ADA Curb Ramp New Construction Inspection Form (Perpendicular)

Nw Kaye way

24952.54

Nw mays st

PERPENDICULAR RAMP (PR)

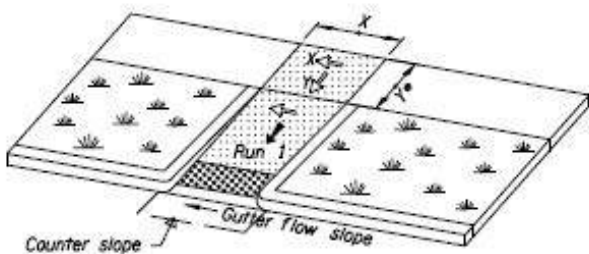
IITD rr1 icrr rr1 crack in panel
